**From:** Caroline Barnett  
**Sent:** 19/08/2024 1:48:14 PM  
**To:** Council Northernbeaches Mailbox  
**Subject:** PEX2024/0005 Barnett and Lowe  
**Attachments:** PEX20240005 Barnett and Lowe submission.pdf;

August 19, 2024

Firstly, we're concerned the notification map wasn't included in the documents. This seems inconsistent with other submissions especially as this is a re-zoning issue. I have learnt only the immediate neighbours have been notified which is insufficient for a re-zoning proposal that effects all of Freshwater. It also seems inadequate the documents disappeared from your website over the weekend of August 17-18 and the search function gives no results when searching using the proposal number, the map function or 64 Undercliff Road.

### Zone R2 Low Density Residential

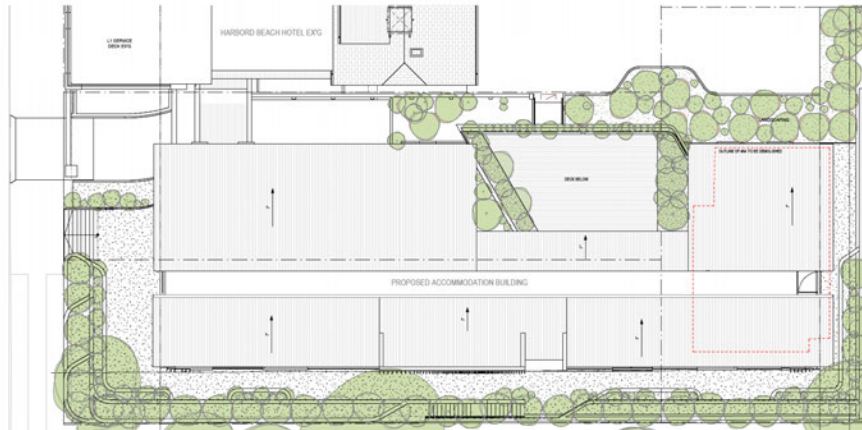
- To provide for the housing needs of the community within a low density residential environment - A hotel does not support this intent.
- To enable other land uses that provide facilities or services to meet the day to day needs of residents - In fact as a resident my view is that a hotel is contrary to my day to day need for peace and quiet and safety of my three children. We would go from knowing and trusting our neighbours to having a rotation of strangers across the road with their hotel rooms facing 3 bedrooms on our property. I have an 11 year old and two teenagers. This is very inappropriate.

- To ensure that low density residential environments are characterised by landscaped settings that are in harmony with the natural environment of Warringah - A three level hotel block is definitely not in harmony with the natural

- The total building footprint(s) must not cover more than 33.3% of the site area. The 33% would need to be met under R2 zoning rules. Can you supply documentation of this as the plan below looks to cover much more than 33%? I would assume council won't allow any of the existing trees on the nature strip (council land) to be removed as this is an existing green screen between the residents on Undercliff and the pub.

**Heritage Impact**

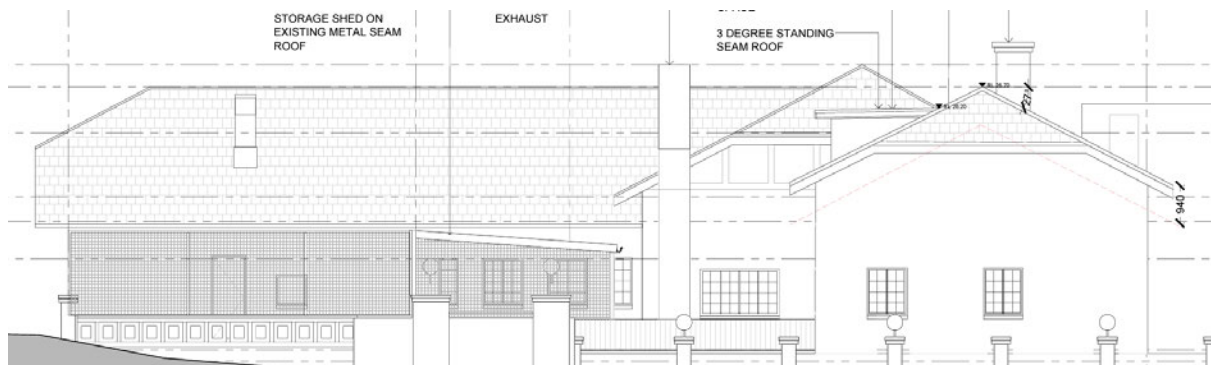
The Planning Proposal is supported by a Heritage Impact Statement by Weir Phillips (**Annexure 5**) which confirms that the Hotel previously provided accommodation on the site and as such, the proposal is in keeping with the original and historical use of the site. If this is the case, in keeping with the heritage of the building the accommodation should be maintained within the existing heritage building.

The heritage report claims that the 'proposed change of use to permit hotel accommodation is **consistent with the character of the area** and responds to the changing nature of hotel accommodation demonstrating a preference for purpose built hotel/motel accommodation rather than staying above an operating hotel.' - Hotel accommodation isn't at all consistent with the character of Freshwater, as there are no other hotels.

The heritage report notes the rear of the building has been extensively altered with several additions. The rear of the building does not clearly demonstrate the key aesthetic characteristics of the c.1928 era of construction. If this is the case, why hasn't the council suggested in previous or current DA's that this should be rectified to maintain the heritage integrity of the building?

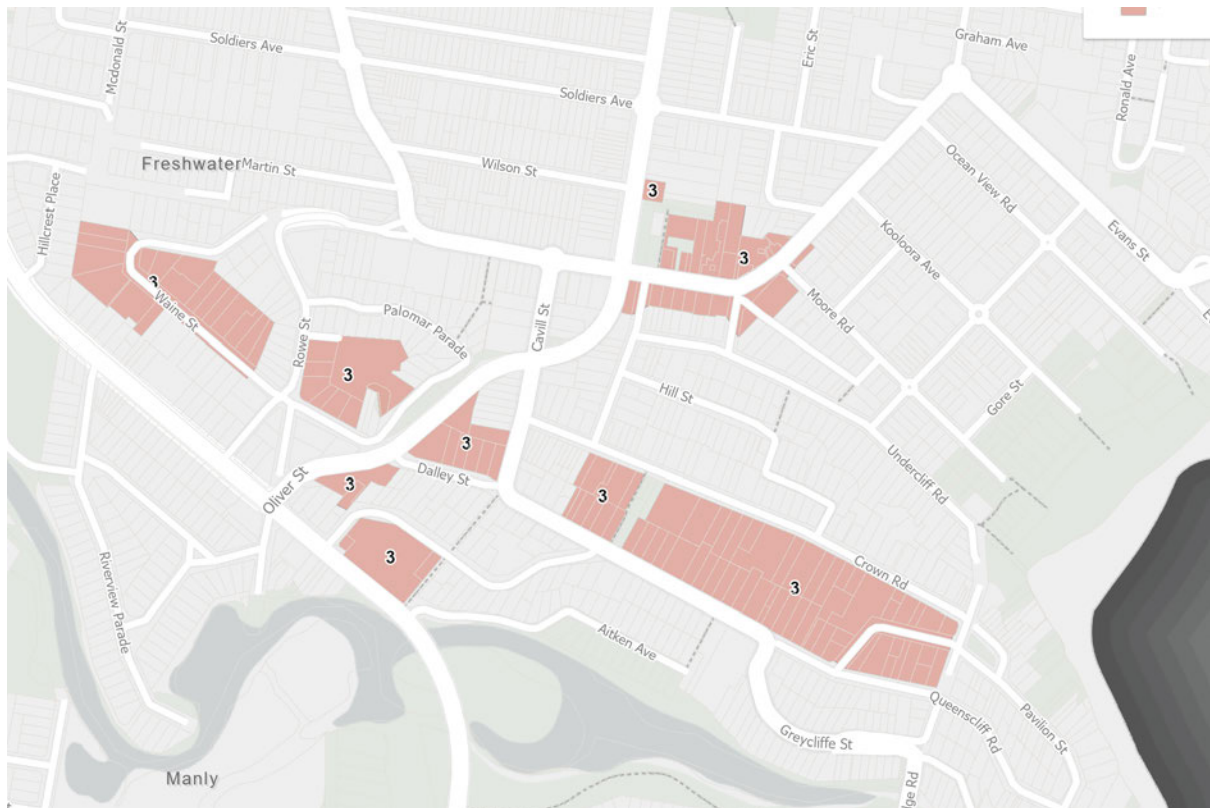
If council were to allow and amended use of their R2 zone, then the residents directly across the road on Undercliff Road could collectively sell and build a hotel with ocean views. As we're on steep blocks, under R2 restrictions we could build 5 levels stepping back. Under this precedence we could also ignore the 33% building

footprint and destroy the bandicoot habitat.
